NAUTICAL CARTOGRAPHY WORKING GROUP (NCWG)

NCWG Letter: 09/2016

Subject: NCWG2 Actions 10, 15, 23, 25, 26, 43 – Follow-up to Letter 05/2016

CONSOLIDATED RESPONSES TO NCWG LETTER 05-2016

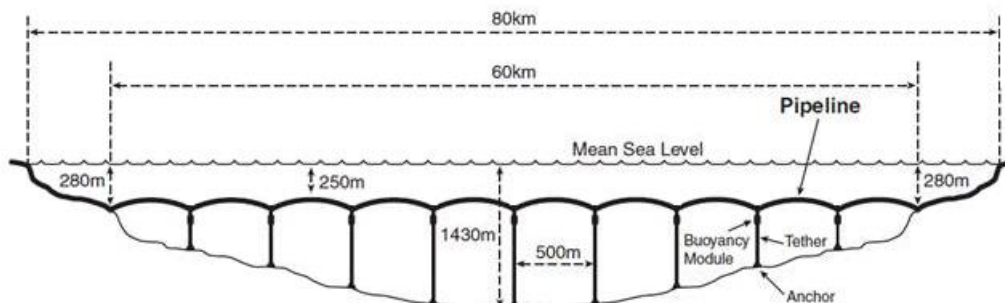
15: Although "tether" appears in the diagram, so does "anchor." Recommend using "anchored" in B-444.9.

Bülent Gürses (TR) showed some pictures of the construction phase of the sub-surface floating pipeline, which helped the meeting understand the details of this feature. The recommended addition to S-4 in the paper was generally accepted with the following amendments:

The example diagram should be adjusted to remove the appearance of buoys above the pipeline and to show the depth marker above the highest part of the arc.

Chair comment: Strictly, the pipeline is tethered to the anchor which is embedded in the seabed. Either word would be correct but, on reflection, perhaps 'anchored' would be better in a nautical publication such as S-4.

B-444.9 Sub-surface pipelines that are floating in the water column and anchored....

Sub-surface pipelines must be shown, where required, using the appropriate pipeline symbol as specified in clauses B-444.1 and B-444.2 above. To indicate the minimum design depth of the pipeline, a legend similar to *Water (submerged 250m – see Note)* must be placed along the pipeline, repeated as required if the pipeline extends across a substantial area of the chart. A cautionary note should be charted, for example:

A pictorial representation of the sub-surface pipeline, for example as shown above, may be included in addition to, or in lieu of, the note, in magenta, see B-390.1. If the diagram is included in lieu of the note, the legend along the pipeline symbol should read similar to *Water (submerged 250m – see Diagram)*.
